RE: Z-50-15-2 – Northeast corner of 41st Street and Greenway Road

Subject: ITEM 68 ON THE FEBRUARY 3, 2016 FORMAL AGENDA – REQUEST TO ADD STIPULATIONS FOR EMERALD BAY SENIOR LIVING PUD, Z-50-15-2 (G-6129)

ORDINANCE G-6129

Second Floor Window Exhibit

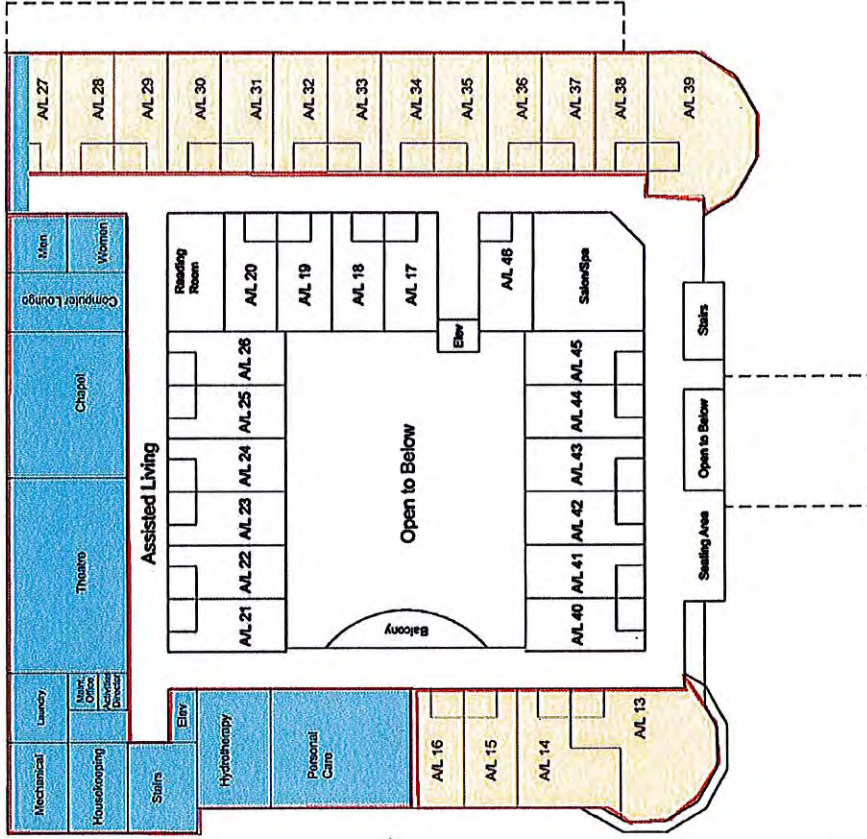
“NORTH AND WEST ELEVATIONS:
ONLY CLERESTORY OR OPAQUE WINDOWS SHALL BE PERMITTED ON THE SECOND FLOOR OF THE BUILDING, FACING NORTH AND WEST, TO PREVENT VIEWS INTO THE NEIGHBORHOOD AS SHOWN IN BLUE ON APPENDIX 6, SECOND FLOOR WINDOW EXHIBIT DATE STAMPED FEBRUARY 3, 2016.”

- (1) ADD THE MAXIMUM 25-FOOT BUILDING HEIGHT, AS MEASURED PER THE ZONING ORDINANCE STANDARDS.
- (2) REVISE THE WEST SIDE ELEVATIONS TO INCLUDE EITHER CLERESTORY OR OPAQUE WINDOWS ON THE SECOND FLOOR OF THE BUILDING, TO BE CONSISTENT WITH THE BLUE AREA ON THE SECOND FLOOR WINDOW EXHIBIT DATE STAMPED FEBRUARY 3, 2016.
- (3) REVISE THE STREETScape IMAGES TO REPLACE THE SIX-FOOT HIGH WALL ALONG GREENWAY ROAD WITH A THREE TO FOUR-FOOT HIGH WALL.

*Only Clerestory or Opaque Windows

Revised 2nd Floor Plan
